| Meeting name | BSC Panel |
| Date of meeting | 15 January 2009 |
| Paper title | Decision on CP1260 - Meter Investigation Process where a Site is Capable of Exporting (microgeneration) |

Diagram 2:

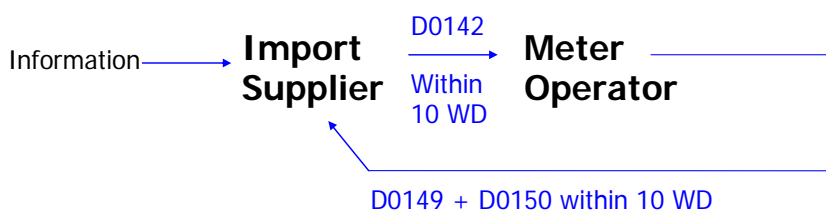
The majority of respondents stated their preference for the D0001 solution (option 3). The reasons provided were that it was a streamlined solution that used investigative flows for the process. Several respondents highlighted that the D0142 (option 2) was not appropriate as the D0142 is a flow which is used to replace meters and cannot be used for investigative purposes. Detailed responses are available at the [DCP0030 webpage](#).

The majority of respondents to the DCP0030 v2.0 consultation preferred the D0001 solution, so this is the option that was progressed into CP1260.

Figure 1(above): illustrates the model as proposed by CP1260.

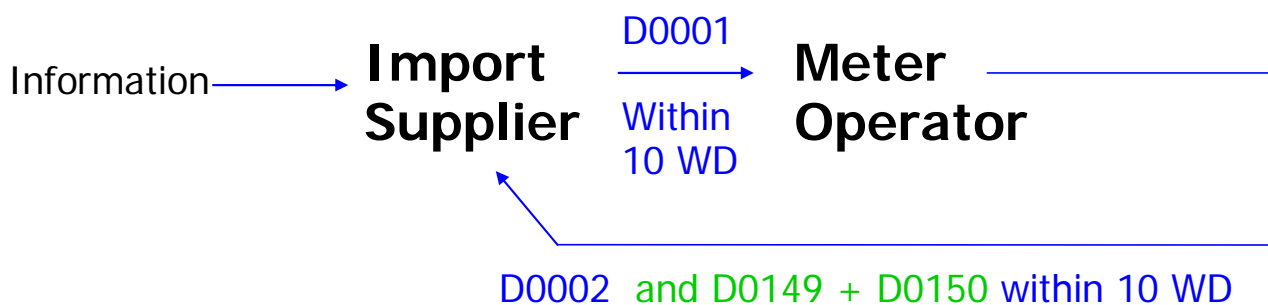
| EDF Energy | X | <p>Disagree: Please see details of response to CP 1259. Supplier has same problem with D0002 from MOP as with D0001 from LDSO.</p> <p>Capacity in which Organisation is impacted Supplier and MOP</p> <p>Impact on Organisation: Current process for dealing with manual D0002s would need to be amended to identify these flows. We think it would be easier to resolve this with a specific requested action code so that flows with this code could be routed to relevant team based on this new code.</p> <p>Implementation: If site visit check code change was made then we do not think that this change would be possible until June 2009.</p> <p>Would implementation in the proposed Release have an adverse impact? Provided MOP does not send a D0002 requesting further action and changes meter if cannot install backstop then should not be an issues. If not then there is a chance that these D0002s could get missed and settlements impacted.</p> | ✓ | 90 | <p>EDF explained that they support this change only if the MRA CP is approved, and if this CP is implemented in June 2009.</p> <p>EDF explained that if the MRA change was rejected, that it would lead to increased manual processing of D flows.</p> <p>Response noted. The proposed implementation date has been moved to June 2009.</p> |
| Scottish and Southern | X | <p>We are not convinced that the D0001 is the correct flow to use. A D0001 flow is to investigate faults/discrepancies on</p> | ✓ | 365 | <p>BSCCo explained that the D0001 was chosen by the</p> |

| | | <p>communication failures A D0142 flow is a request for suitable metering. Following the site visit, a D0002 if meter installed is suitable or a D0149/D0150 if new meter fitted. Not both flows.</p> <p>Impact Changes to system and processes</p> | | | <p>majority of respondents as the preferred solution in DCP0030 consultation.</p> <p>Scottish and Southern have expressed concerns that on a Change of Supplier, the new Supplier may not be aware that customer has equipment capable of microgeneration and remain in disagreement with this CP.</p> |
| Siemens Metering Services | X | <p>As in our previous response to DCP0030, Siemens Metering Services still believe that the D5 flow would be more appropriate than the D1, for the Supplier to request the site visit from the MOA.</p> <p>The D1 flow relates to Meter fault investigations, and therefore it is misleading to use this type of flow in this instance. D1s and D5s are handled differently. If CP1260 is implemented, this will create a need for manual intervention in order to sort through the D1 fault investigation flows to identify those which require visits to identify if backstops are required, or if the meter requires replacing.</p> <p>Capacity in which Organisation is impacted MO</p> <p>Impact on Organisation: Process changes would be required.</p> <p>Would implementation in the proposed Release have an adverse impact? No adverse impact, assuming implementation is February 2009 (above states date as</p> | ✓ | 90 | <p>BSCCo explained that the D0001 was chosen by the majority of respondents as the preferred solution in DCP0030 consultation.</p> <p>BSCCo noted that February 2008 was erroneously reported on the CP response form and confirmed that this CP was due to be implemented in February 2009. However the proposed implementation date has been changed to June 2009.</p> <p>Siemens Metering Services remain in disagreement with this</p> |
